Appl. No. 10/808,721
Amdt. dated June 9, 2005
Reply to Office Action of January 11, 2005

Amendments to the Drawings:

REMARKS/ARGUMENTS

Fig. 1

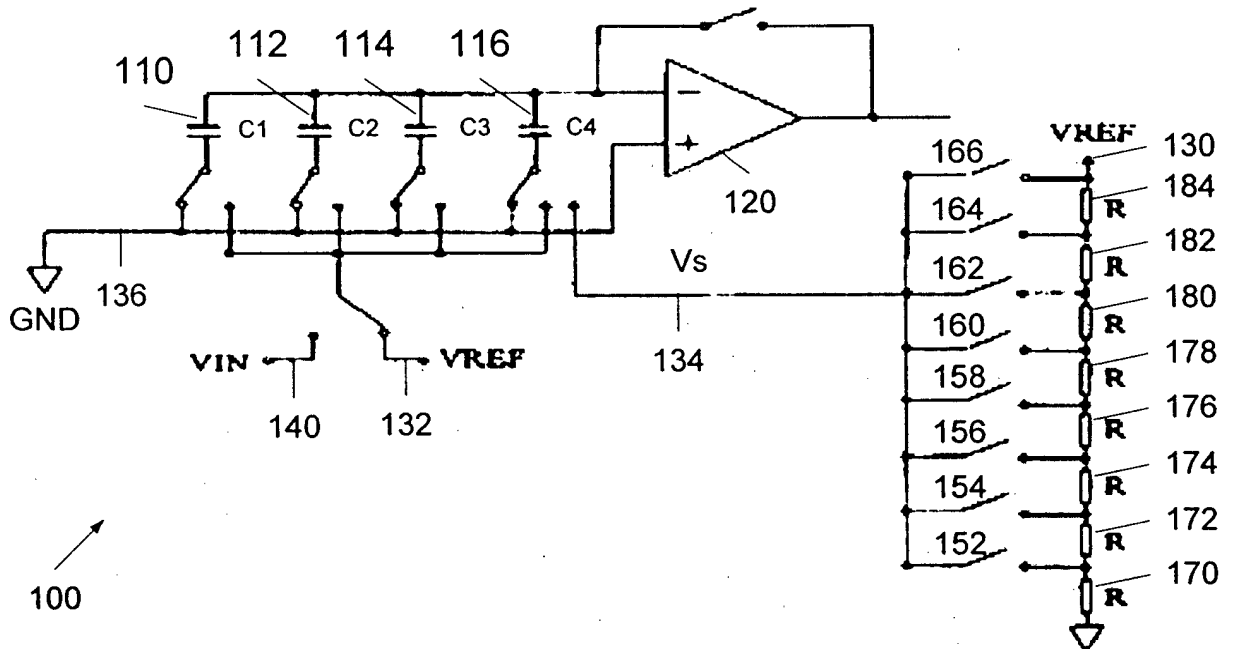
The attached sheet of drawings includes changes to Fig. 1. This sheet, which includes Fig.1 replaces the original sheet including Fig. 1.

Applicant has added “Prior Art” to Figure 1, and respectfully submits that the objection to Figure 1 has been overcome.

Prior Art
